QF7351/JT

9th December 2014

Re: 11 Fitzroy Square – Additional Condenser within Front Vault

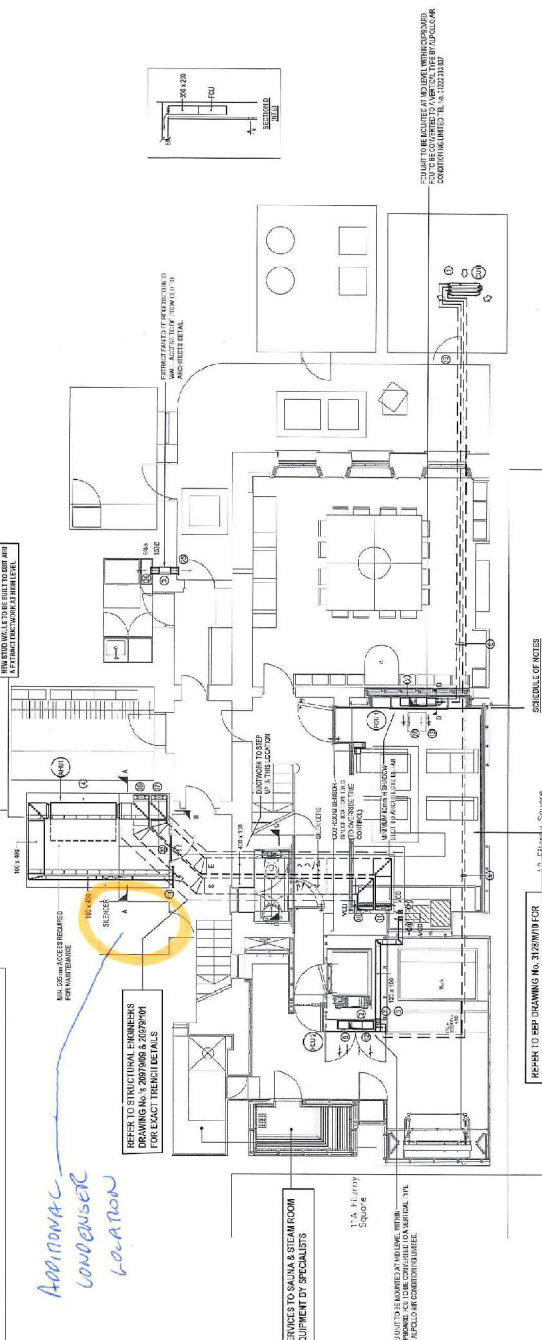
Since the issue of our acoustic report reference QF7351/PF4765/RP1, we acknowledge your request to comment upon the noise impact of an additional condenser installed within a vault at the front at the house. The attached plan has been marked to show the location of the vault, and the attached extract from Fujitsu provides sound power levels of the AOYG14LALL unit proposed.

Within the small vault in which it is proposed to be located, we predict this will result in a reverberant sound pressure level inside the vault in the order of 65dBA.

The vault has a massive construction, so the vault walls will be sufficient to contain all of the condenser's noise. However, we understand that you propose to ventilate the vault via a louvre door set into the front wall of the vault.

we can predict that plant noise levels at 1 metre external to the nearest affected residential window, approximately 8 metres away, will be in the order of 38dBA.

As 38dBA is less than the recommended design noise limit of 41.6dBA, it is predicted that the introduction of a the above specified condenser should attract no justifiable complaints under the guidelines set out in Camden's planning policies and as such reservations are not expected from the planning authority on the grounds of noise.

Using acoustic louvres in lieu of non-acoustic louvres would provide an additional reduction in noise and allow a margin for error in our above calculations.
